Waste Licence Review Application W0167-02

Response to Article 13 Compliance

December 2009

TITLE: MAIN PROCESS AND AIR CONDENSER BUILDINGS, PLAN VIEW
 PROJECT: 70MW WASTE TO ENERGY FACILITY, CARRANSTOWN.

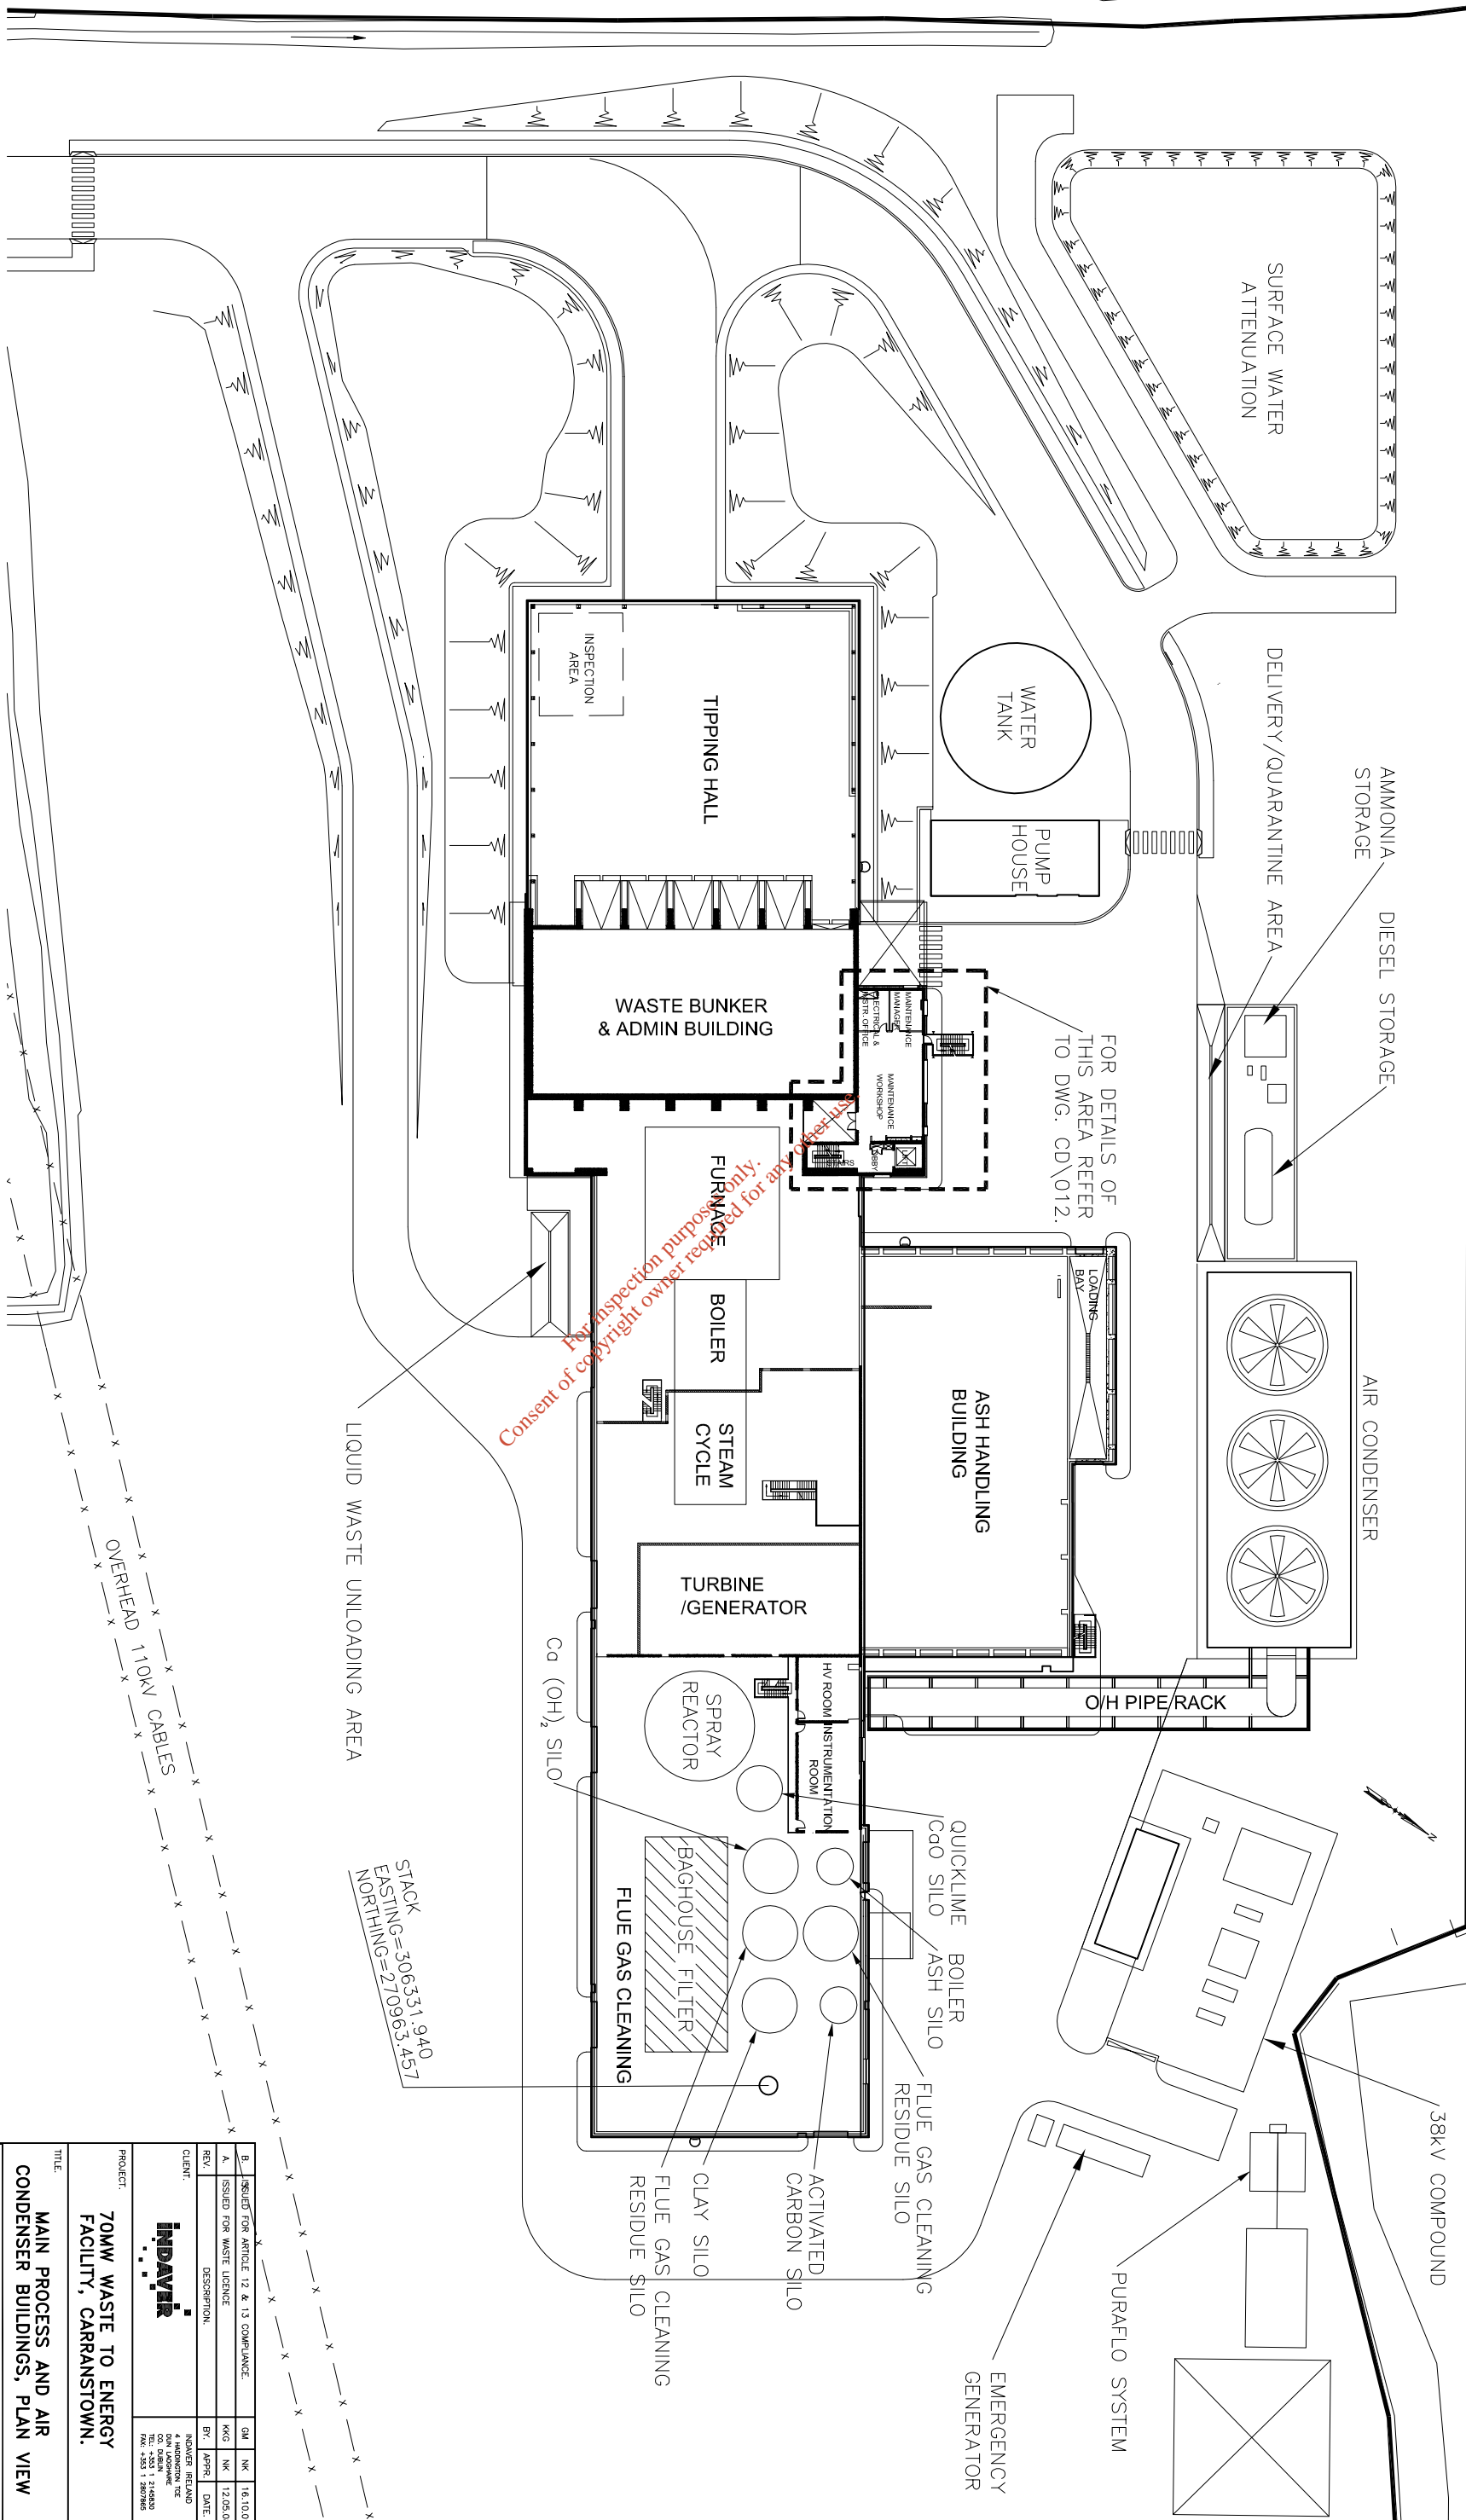
Appendix D1: Site Layout	The site layout has been revised with changes to the main process building shape, addition of an ash handling building, removal of the turbine building and warehouse, redesign of the gatehouse, parking and stormwater attenuation and relocation of the air condensers, storage tanks, pumphouse and quarantine area. These modifications are summarised in Section 1.1 of the 2009 EIS. Drawing 151013\WL\005 has been revised to Drawing 18081\WL\005 in Appendix 13.b
Appendix D2: Site Entrance Drawing	The Site Entrance drawing 15013\WL\007 has been modified to show minor changes in the gate, which now comprises a single rolling panel, and to the design of the wall. Refer to Drawing 18081\WL\007.
Appendix D3: Plant Layout	The plant layout has been revised with changes to the process building shape and removal of the turbine building. Drawing 15013\WL\008 has been revised to Drawing 18081\WL\008 in Appendix 13.b.

After passing the weighbridge and gatehouse, liquid tankers will drive to a designated unloading area at the side of the main process building as shown in Drawing 18081/WL/008. Tankers will be connected to the unloading pump using flexible hoses and couplings. The liquids will be pumped from the tankers via piping to a nozzle in the furnace where they will be injected into the furnace above the grate.

<p>PROJECT: 70MW WASTE TO ENERGY FACILITY, CARRANSTOWN.</p>		<p>CLIENT: INDAVIA</p>	
<p>TITLE: PROPOSED SITE DRAINAGE LAYOUT</p>		<p>DESIGNED: NK</p>	
<p>DESIGNED BY: NK</p>		<p>CHECKED: NK</p>	
<p>DATE: AUG '09</p>		<p>SCALE: N.T.S. @ A3</p>	
<p>DRG. No. 18081\WL\006</p>		<p>REV. B</p>

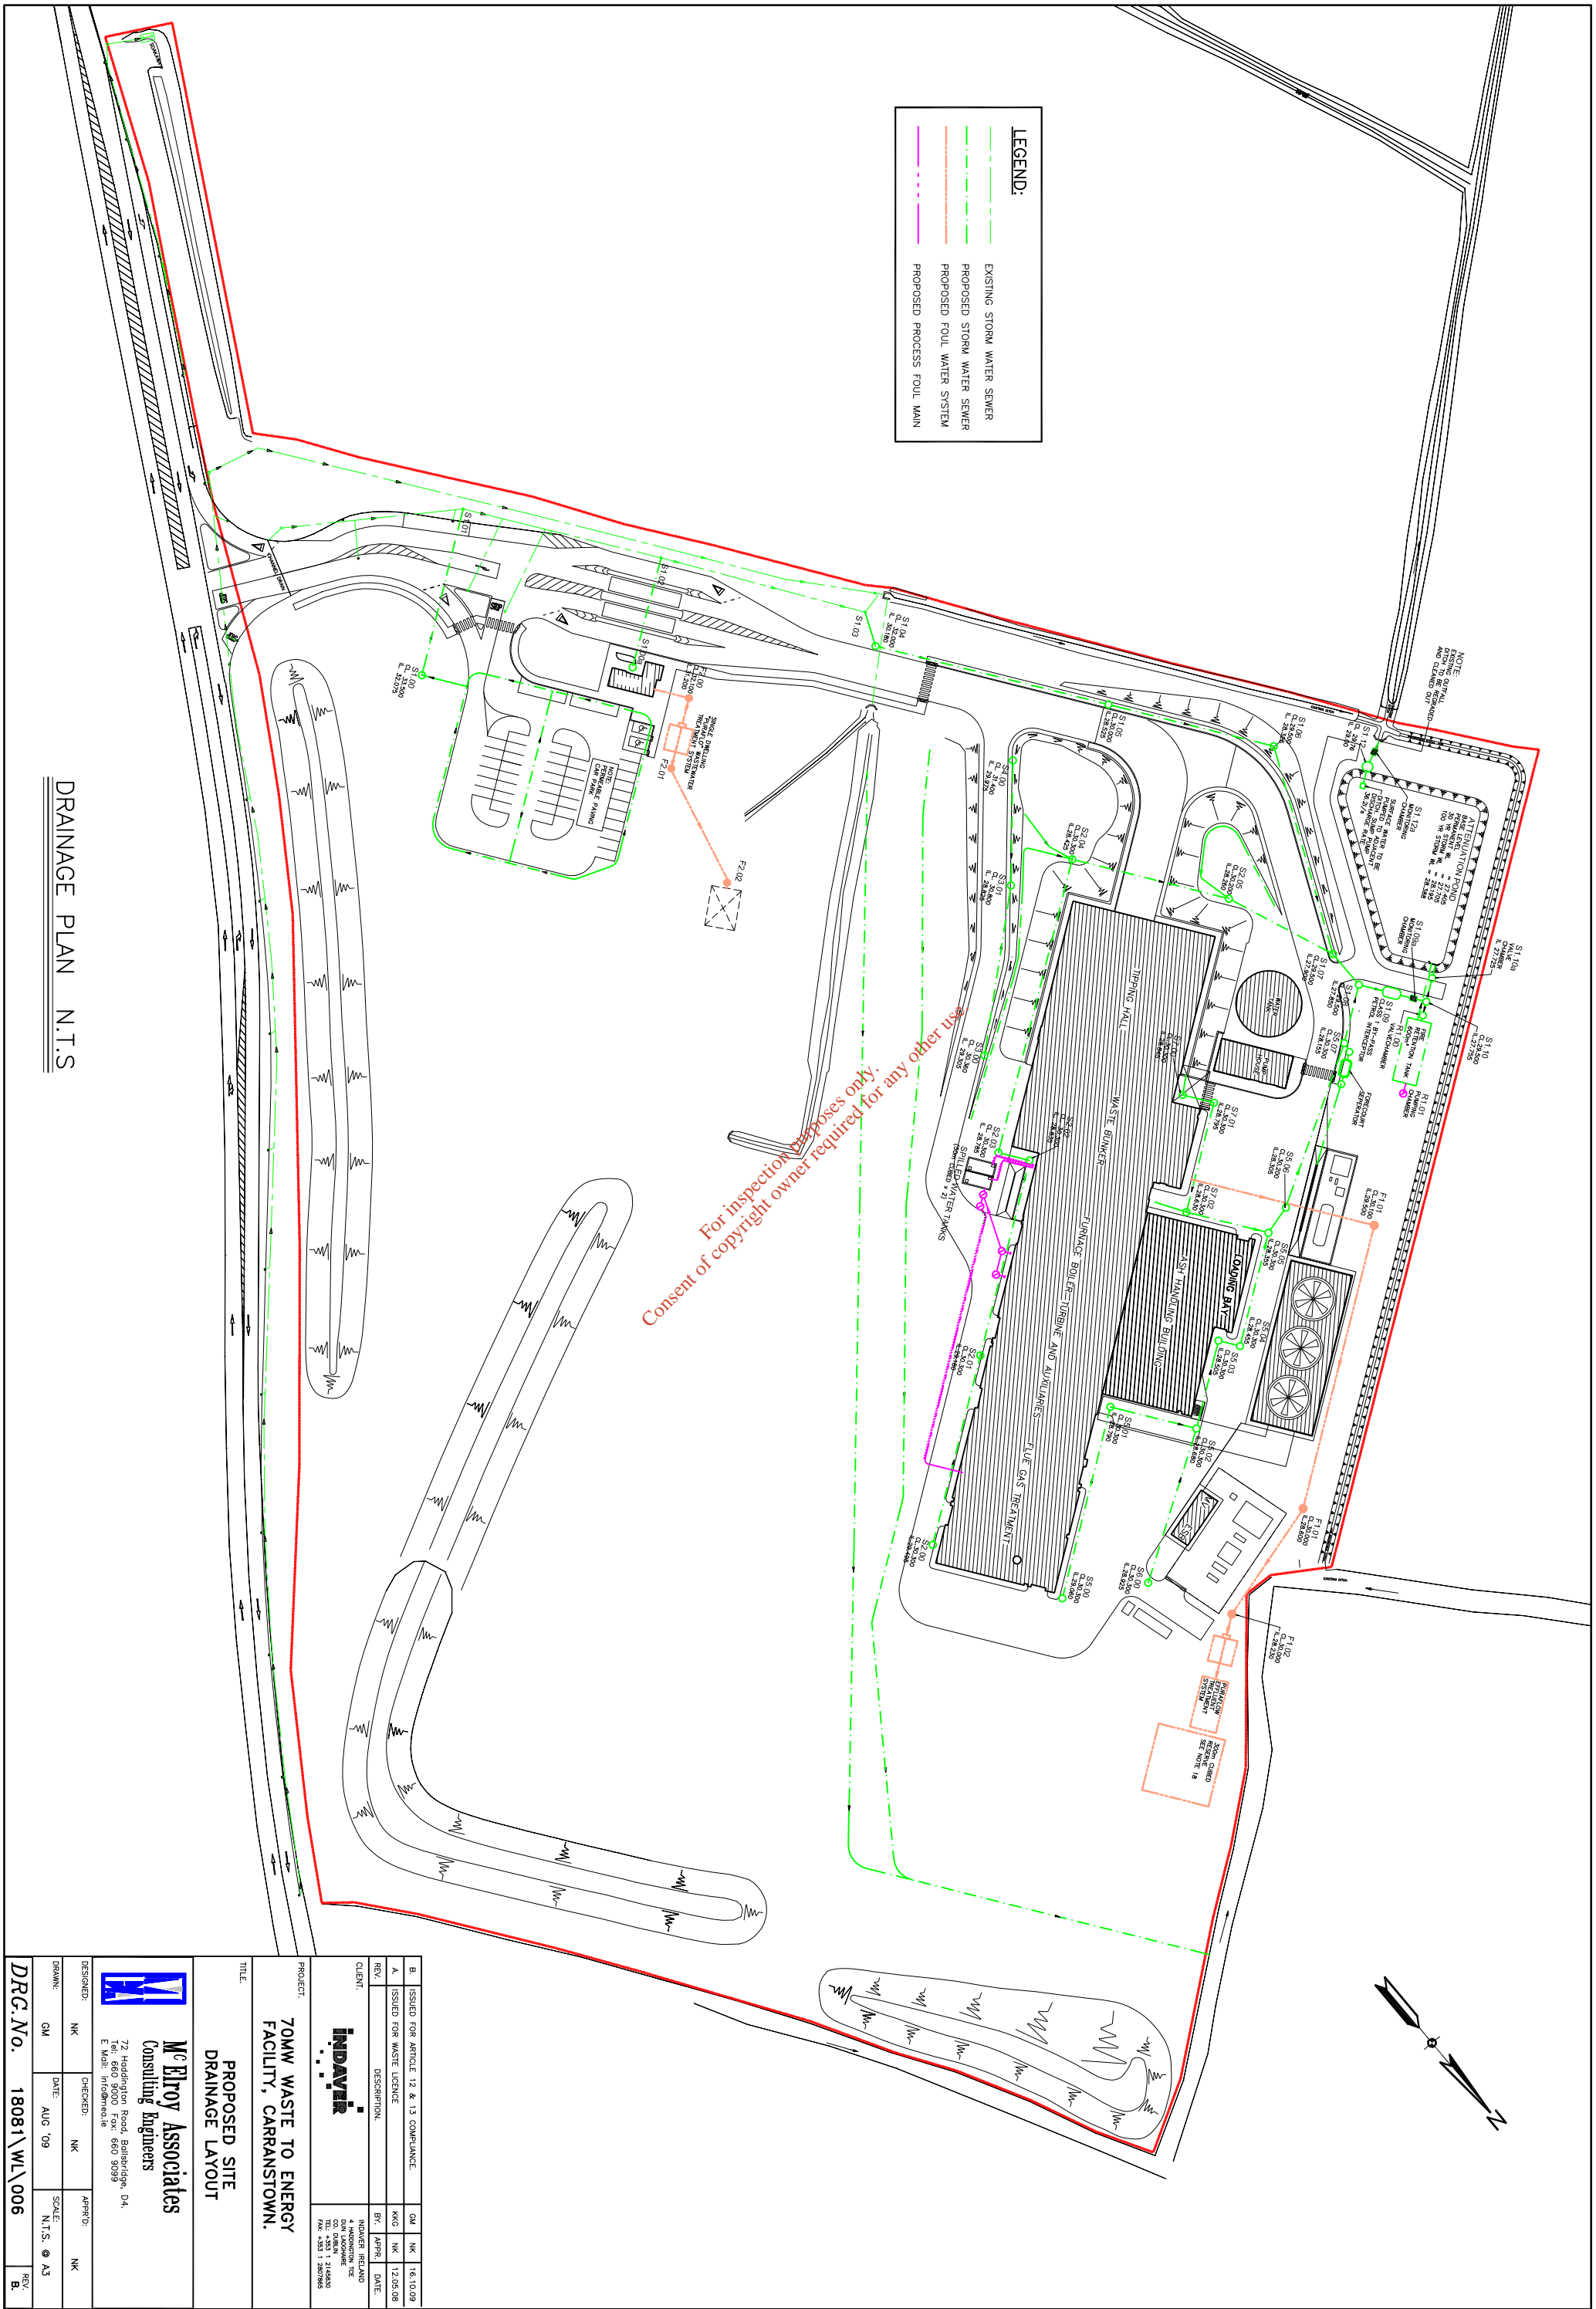
Attachment	Modifications
Attachment D: Infrastructure & Operation	<p><u>Attachment D.2.7</u>: Bottom ash will be conveyed to a bottom ash handling building rather than a bunker. This is described in more detail Section 5.6.11 of the 2009 EIS.</p> <p><u>Appendix D1-3,5,7,8,9,11</u>: Drawings have been revised as per Table 13.c and Appendix 13.b.</p> <p><u>Appendix D6</u>: The stormwater attenuation tank has been revised from a hydrocell construct to an above ground pond. Appendix D6 of the RWLA therefore no longer applies.</p>
Attachment E: Emissions	<p><u>Attachment E.1.1</u>: The stack width of the main emissions point (A2-1) has been revised from 2m to 2.2m. The maximum 24 average flowrate has also been revised down from 204,000Nm³/h to 147,000Nm³/h with the average flowrate set at 134,000Nm³/h as described in response to Question 5(a)(i) of Article 12 Compliance. This has reduced the efflux velocity from 17.8m/s to 16.4m/s (at 147,000Nm³) as used in the revised model. The minimum efflux velocity, at 134,000Nm³ is 14.95m/s. The emergency generator (A2-2) has also been relocated as shown in Drawing 18081\WL\008. This revised location was included in updated modelling in Section 7 of the 2009 EIS. The volume and nature of emissions from this generator have not changed as noted in Appendix 7.3 of the 2009 EIS.</p> <p><u>Attachment E.1.2</u>: The SNCR reagent will be ammonia. The ammonia tank will not be located in the main process building but in the service yard adjacent to the air cooled condenser building. Refer to Drawing 18081\WL\008.</p> <p><u>Attachment E.2</u>: Changes to surface water emissions are described in more detail in the Response to Question 4 of Article 12 Compliance and in Section 11 of the 2009 EIS. The main amendment is an increase to the discharge rate from 16.98l/s to 36.2l/s. The reference to a Class II full interceptor in Table E.2.a should read "Class I".</p> <p><u>Attachment E.4.1</u>: There will be two percolation areas rather than one for the two Puraflo systems installed. While expected emissions from the Puraflo brochure were provided in the Revised Waste Licence Application (Table E.4.a), design emissions have now been confirmed by the supplier as set out in Appendix 9.5 of the 2009 EIS which are B.O.D. of 20mg/l (rather than <15mg/l) and TSS of 30mg/l (rather than <15mg/l). These emissions are based on EPA wastewater treatment manuals. Details on percolation testing are available in Section 9.3 of the 2009 EIS and further information on the quality of discharge from the Puraflo systems is provided in Appendix 9.5 of the 2009 EIS. Drawing 18081\WL\006 shows the location of the two percolation areas.</p>
